## IDAP REPORT

<b>Property:</b>	8 Wilson Street STRATHFIELD Lot: 141 DP: 14613 DA2021.307
<b>Proposal:</b>	Demolition of existing dwelling and associated structures and construction of a two-storey house with at-grade double garage and in-ground swimming pool.
<b>Applicant:</b>	C Jiang
<b>Owner:</b>	H Zhang / X ni
<b>Date of lodgement:</b>	29 November 2021
<b>Notification period:</b>	3 December 2021 to 17 December 2021
<b>Submissions received:</b>	One
<b>Assessment officer:</b>	P Santos
<b>Estimated cost of works:</b>	\$2,028,400.00
<b>Zoning:</b>	R2-Low Density Residential - SLEP 2012
<b>Heritage:</b>	No
<b>Flood affected:</b>	Yes
<b>RECOMMENDATION OF OFFICER:</b>	APPROVAL

Figure 13. Extract of the illustrated TPZs of Tree 14 (left) and 15 (right) and their proximity to the proposed swimming pool.

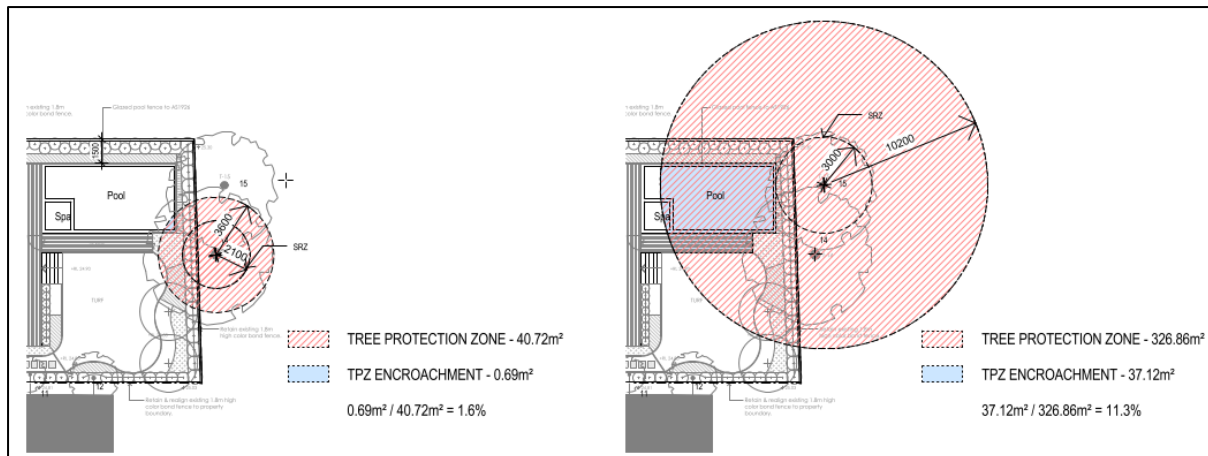
***"Tree 14,15 – neighbouring trees are impacted by the proposed pool and these works in the current location could compromise the stability of the trees."***

Council's Tree Management Coordinator concluded with a further request to explore the possibility of relocating the proposed pool to retain the neighbouring trees (Trees 14 and 15).

The proposed development satisfies the relevant objectives and controls with SCDCP 2005. However, it is conflict with the existing trees to the neighbouring property to the east that the excavation for the pool will impact the viability of the trees to survive.

Council's Tree Management Coordinator raised concerns about the location of the pool and its proximity to the subject trees (Trees 14 and 15). As a resolution, the pool will be conditioned to be either deleted or redesigned in a way that it needs to be relocated to move away from the trees and will not have any impact to the tree protection zones of the trees.

To resolve the issue about the location of the pool and its encroachment with the neighbouring tree, a condition is imposed for the swimming pool to be deleted or redesigned prior to receipt of the construction certificate that would satisfy the requirements to protect the subject neighbouring trees, in particular Tree 15 which has 10.2m TPZ. The condition would require for the amended design to seek approval of Council's Tree Management Coordinator prior to receipt of the CC.

A condition will be imposed that the pool, when redesigning, must be setback at least 1m from the boundaries to any ancillary coping and that if it is more than 0.6m above the ground, it should have no more than 0.3m wide coping to avoid any potential overlooking to neighbouring properties.
